TO: Jim Bach & Town Board Members  
FROM: Don Owens, Chairman, Planning Board  
DATE: September 14, 2016

Reference No. 11119265

**Re: Preliminary Plat Review  
Aurora Mills Cluster Subdivision**

"outer loop"

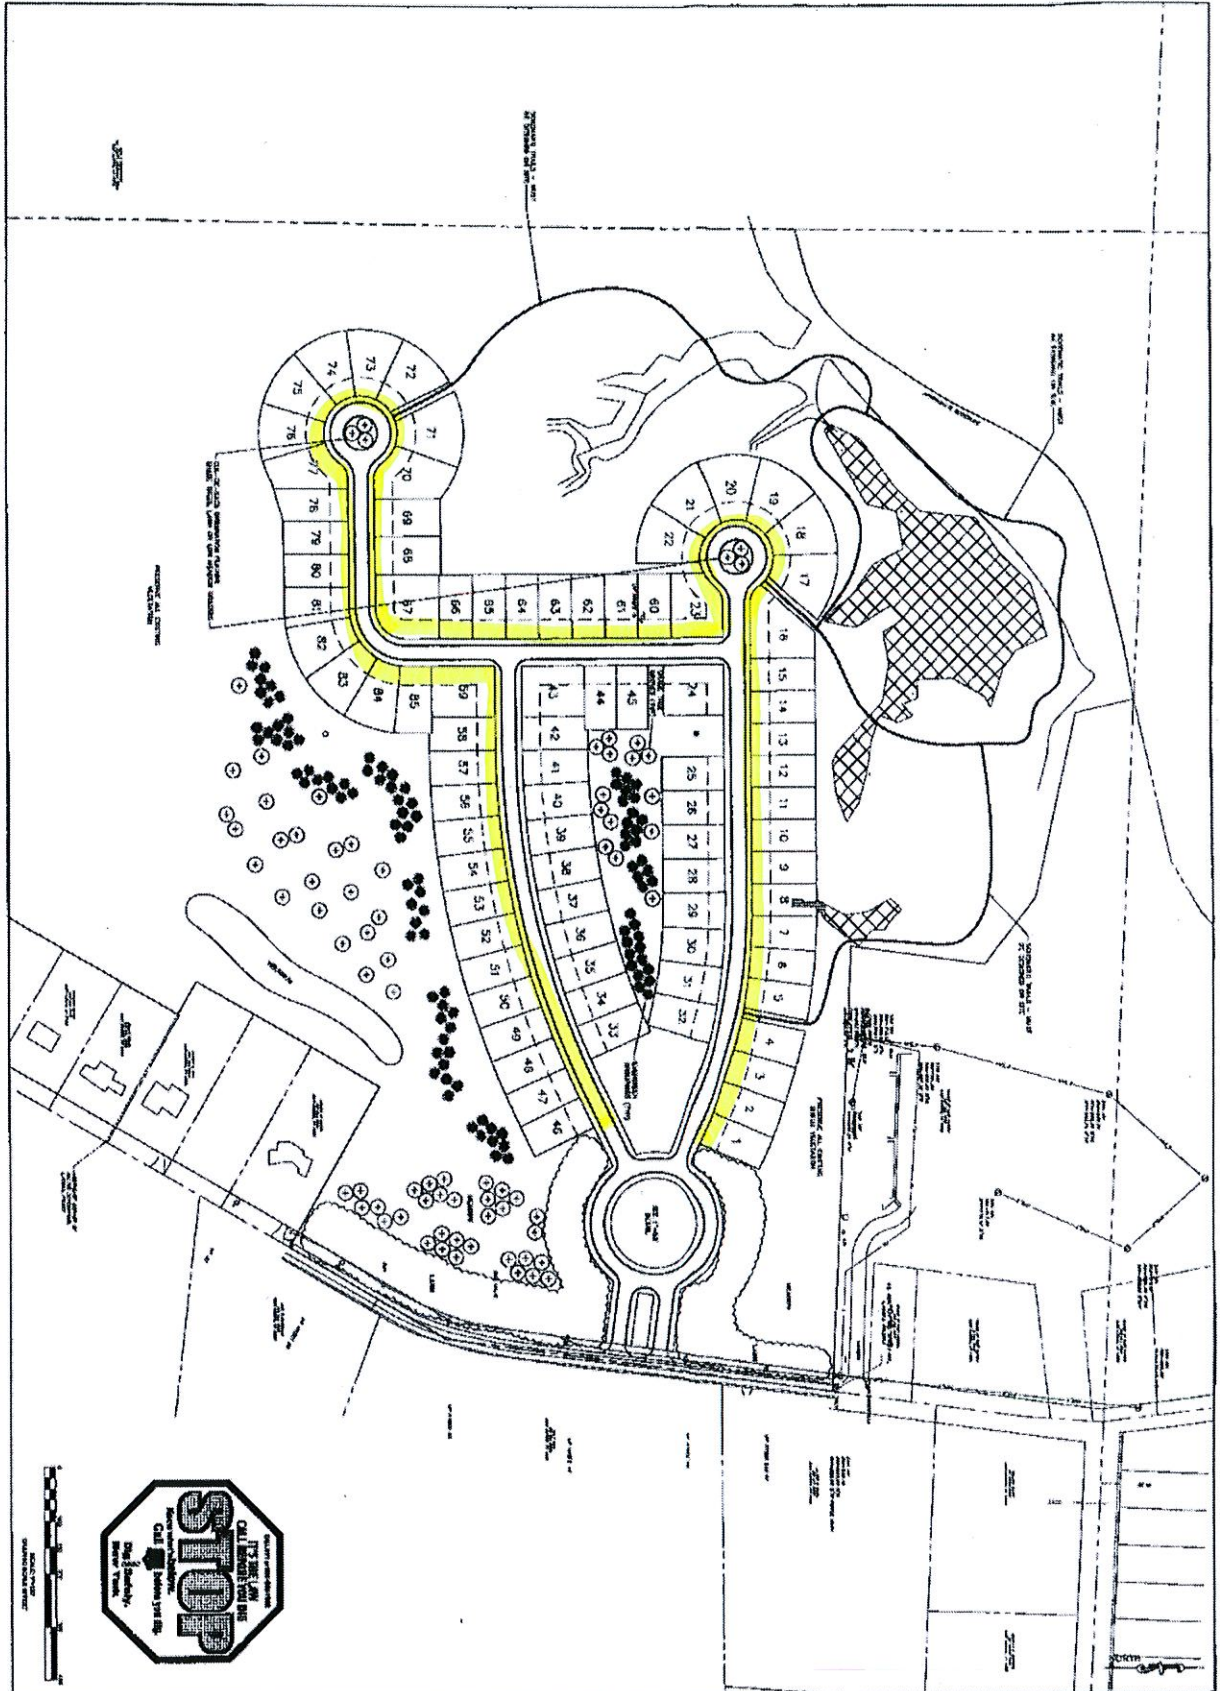
1. Require sidewalks on either the inner or outer loop of the subdivision.
2. Address the items listed in the report from GHD (attached).
